**Service information**

**Reference no.: SDA\_110517**

Brew Unit with yellow parts

Image1

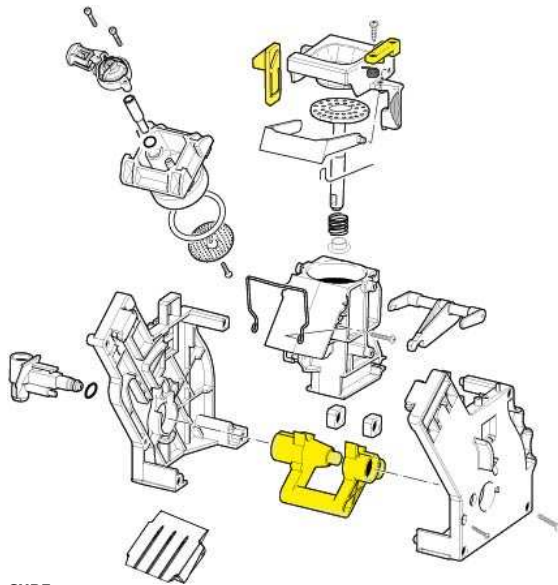
In order to improve both usability and visibility of the BU we are introducing the BU elbow, the coupling plate and the hopper blocking plate yellow colored (see below Image1). This action will also facilitate the communication with the call center agent during the call helping the user to better and faster identify the parts and follow the instructions in case of difficulties.

In case of brew unit replacement order the new parts number in the below table:

In case of replacement of the only yellow parts order:

- Cod. **421944051231**- YLW BREW UNIT ELBOW SHAFT M5000
- Cod. **421944046931**- YLW BREW UNIT COUPLING PLATE V2 SMART
- Cod. **421944050711**- YLW BREWUNIT HOPPER BLOCKING PLATE SMA
